Access Compliance Report

Public Rights-of-Way

(Curb Ramps)

Intersection ID: 31416	Main Street: BRAWER_FARM_DR	Cross Street: IRON_BRIGADE_LN	Location: W
ADA ID: DD8CE7DD71BE	Ramp Type: PerpDiag	Initial Pass/Fail: Fail	Overall Compliance: No
Codes/Mitigation Info/Possible Solution		Field Measurements/Component Compliance

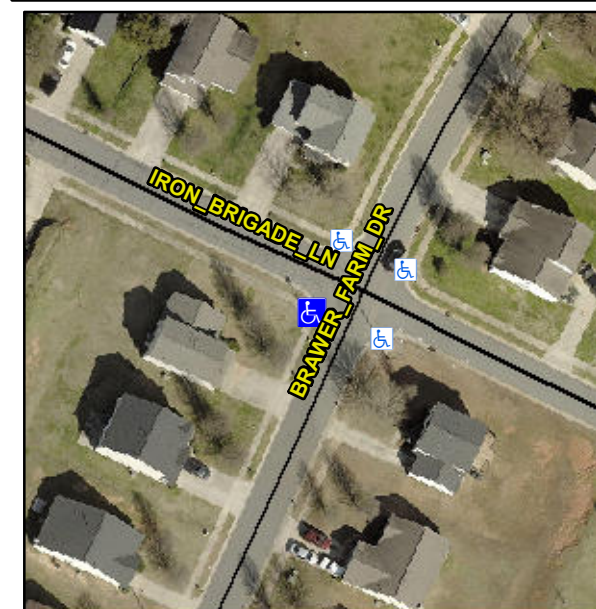
Not Found, R304.5.1, R304.2.2, R304.5.3

Compliance	Description	Data	Compliance	Description	Data
N/A	Ramp Length (in)	47.5	No	Ramp Slope (%)	9.4
No	Ramp Width (in)	46.0	No	Ramp XSlope (%)	6.9
N/A	Flare Type LT	N/A	N/A	Flare Type RT	N/A
N/A	Flare Slope LT (%)	N/A	N/A	Flare Slope RT (%)	N/A
N/A	Flare Traversable LT?	N/A	N/A	Flare Traversable RT?	N/A
N/A	Landing Length (in)	N/A	N/A	DWS Provided?	N/A
N/A	Landing Width (in)	N/A	N/A	DWS Contrast?	N/A
N/A	Landing Slope (%)	N/A	N/A	DWS Length (in)	N/A
N/A	Landing X Slope (%)	N/A	N/A	DWS Full Width?	N/A
N/A	Landing Curb? (Y/N)	N/A	N/A	DWS Offset (in)	N/A
N/A	Shared Landing?	N/A			
N/A	Gutter Ponding?	N/A	N/A	Gutter Slope (%)	N/A
N/A	Gutter Lip Ht (in)	N/A	N/A	Gutter X Slope (%)	N/A
N/A	Painted X Walk1?	No	N/A	Painted X Walk2?	No
	X Walk 1 Direction	To SE		X Walk 2 Direction	To NE
N/A	X Walk 1 Width (in)	N/A	N/A	X Walk 2 Width (in)	N/A
	X Walk 1 Slope (%)	6.9		X Walk 2 Slope (%)	0.0
	X Walk 1 X Slope (%)	1.6		X Walk 2 X Slope (%)	6.6

N/A	Ramp inside XWalk1?	N/A	N/A	Ramp inside XWalk2?	N/A
	Road Slope (%)	3.3	N/A	Clear Space?	N/A
	Road X Slope (%)	6.3	N/A	Clear Space to XWalk (in)	N/A
N/A	Any Obstructions?	N/A	N/A	Storm Grate/Utility Hazard?	N/A
	Obstruction Type			Storm Grate/Utility Type	
		N/A			N/A
			Yes	Surface Condition? (G/P)	Good

Remove & Replace Curb Ramp With Two New Directional Ramps or Equivalent.
